Report of Inspector of Mines

Geotechnical

Inspection No.: 91561  
Mine No.: 0800007  
Permit No.: M-26  
Total Orders: 2

**Mine Name:** Myra Falls  
**Location:** Campbell River, B.C.  
**Owner, Manager:** Glenn Smith  
**Company:** Nyrstar Myra Falls Ltd.  
**Address:** c/o Split Road  
P.O. Box 8000, Campbell River, BC, V9W 5E2

**Photo 3: Price 4 Plugged Ore Pass**

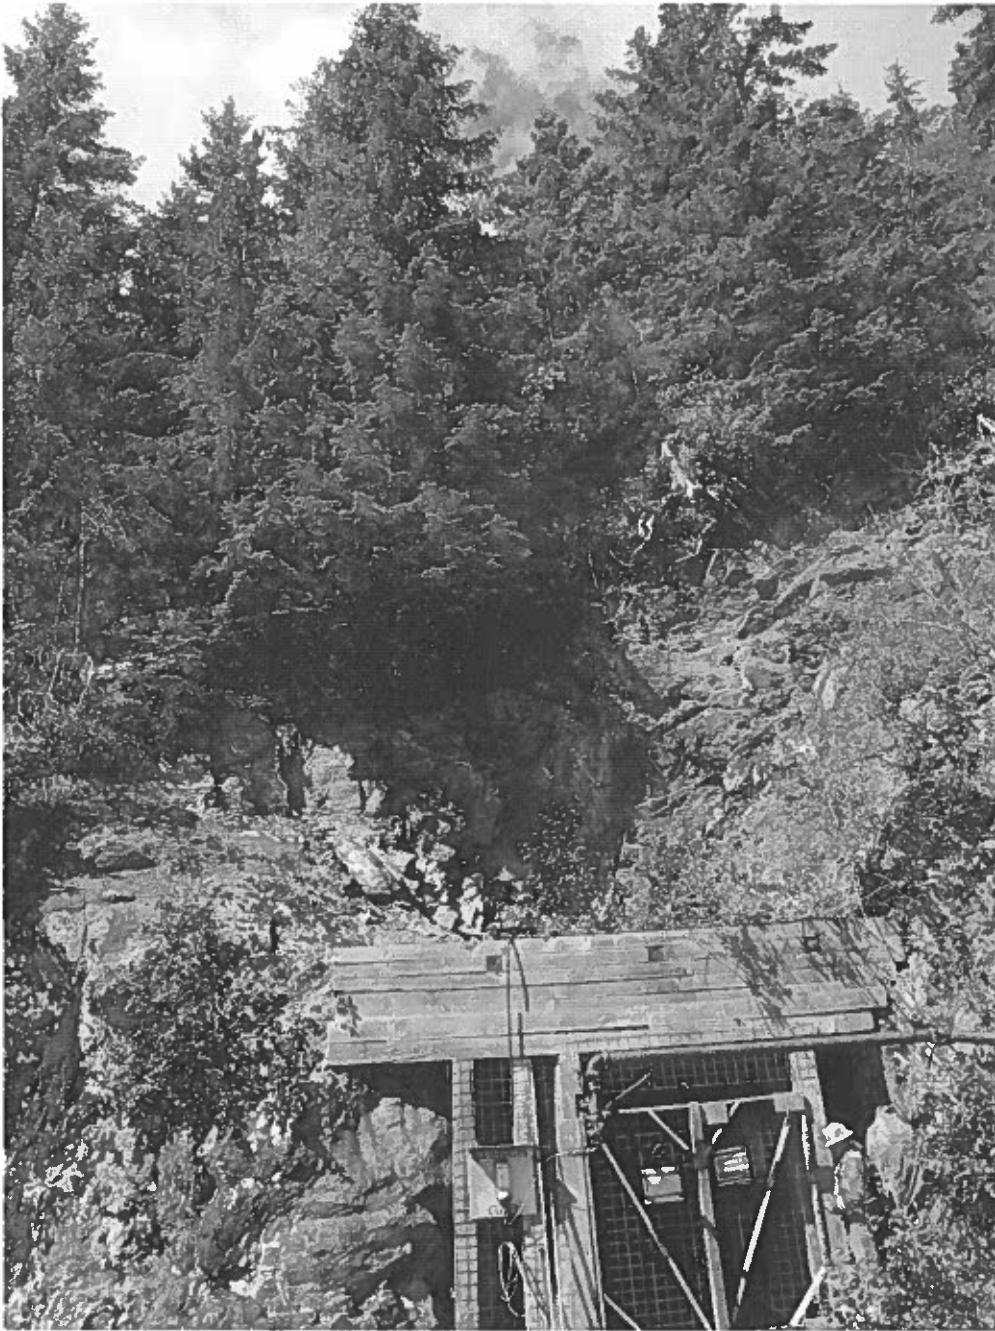
The Ore Pass that connects Price 4 and Price 5 to Price 13 Level is currently blocked. The mine has previously attempted to unplug the ore pass. It is understood that a first attempt to unplug the ore pass consisted of blasting on top of the ore pass in the Price 4 Portal (top of ore pass shown in Photo 3). The second attempt was performed recently and was unsuccessful. The recent work to unplug the ore pass is discussed further in the following section on Price 5.

**Photo 10: Open joint and blocky structure at ore chute haul road cut**

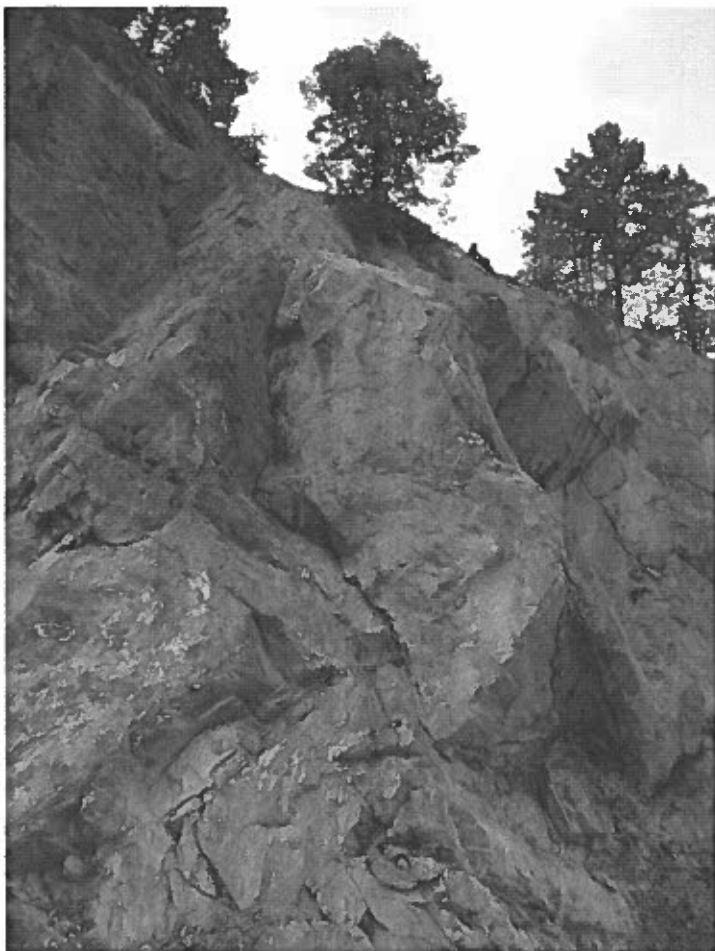
During excavation of the haul route to the ore chute, a historical portal was found along the alignment of the Lynx TDF (Photo 9). The rock exposed in this area also includes some open joints and blocky structure (Photo 10). Nyrstar advised that engineering design work on the dam abutment, including a portal plug, will occur this year.

The rock slope above the Lynx TDF and new ore chute haul road contains open joints and blocks that appear to be potentially unstable.

Pursuant to Code clause 1.9.1, the Mine Manager shall have a Professional Engineer assess the rock slope for stability and implement mitigative measures. A report documenting this assessment and the implemented mitigative measures shall be submitted to the Chief Inspector by the date below or prior to usage of the road for haulage, whichever is earlier.

Area was revisited by a professional engineer and a second letter (Engineering Note) provided. Mitigation actions implemented are: "(i) Scaling (large & small blocks), (ii) Establishment of an exclusion zone below the slope and (iii) establishment of a monitoring program".  
Ref: (i) Eng-Note, July-9, 2018 (ii) Eng-Note, May-30, 2018.
